Re: PETITION NO. 1385 – Cobb Road LLC petition for a declaratory ruling, pursuant to Connecticut General Statutes §4-176 and §16-50k, for the proposed construction, maintenance and operation of a 1.95-megawatt AC solar photovoltaic electric generating facility on approximately 11.16 acres located at 20-1 Short Hills Road, Old Lyme, Connecticut and associated electrical interconnection.

Petition No. 1385
Responses to Interrogatories
Promulgated by #SmartSolarCT

Sheet EC-4:

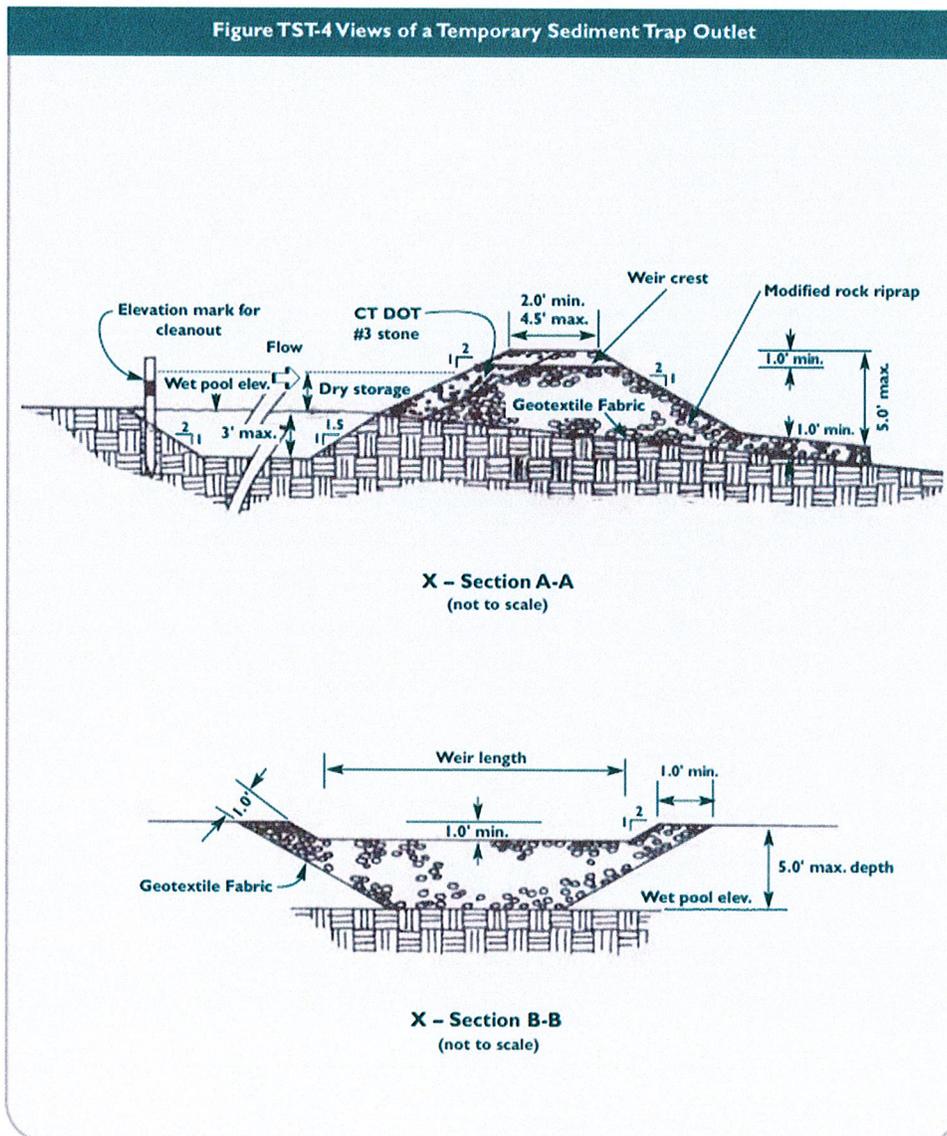
33. The detail for the outlet from the temporary sediment trap shows that the bottom of the spillway is only 12" below the top of the berm. How is the applicant providing a freeboard of 1' which is standard engineering practice for any water impoundment structure?

The detail used in EC-4 referred to by the Intervenor is derived from the *2002 Connecticut Guidelines for Soil Erosion and Sediment Control* (the "E&S Guidelines"), which were promulgated by the Connecticut Council on Soil and Water Conservation in conjunction with the CT DEEP. More specifically, this detail was derived from page 5-11-29 of the E&S Guidelines, Figure TST-4 "Views of a Temporary Sediment Trap Outlet," which is reproduced below:

Per the CT DEEP: “[the E&S Guidelines] are required as the technical standard to be complied with in many municipal planning and zoning regulations and in many permits issued by the Connecticut Department of Energy and Environmental Protection associated with land development.”⁷ Accordingly, the subject detail is in fact the technical standard. To that end, the Petitioner is unsure what source(s) the Intervenor is consulting for its “standard engineering practice[s].”

Exhibit 3
Swale Calculations

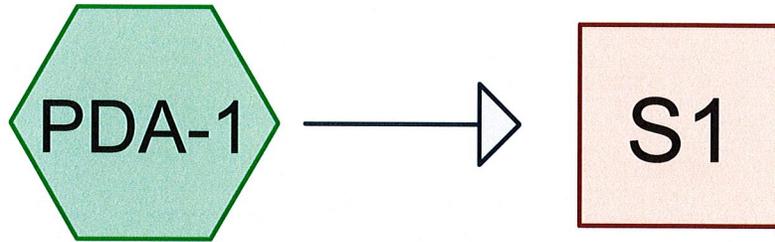
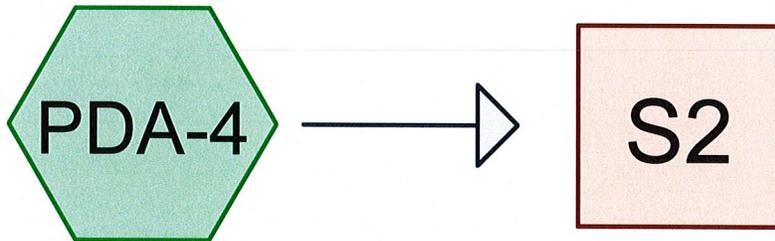
16. Where are the sizing calculations for the proposed swale shown on this plan at the northeast corner of Basin B-1?

17. Where are the sizing calculations for the proposed swale shown on this plan at the southeast corner of Basin B-4?

The sizing calculations for the proposed swale (Basin B-1) are attached as Exhibit 3.

The sizing calculations for the proposed swale (Basin B-4) are attached as Exhibit 3.
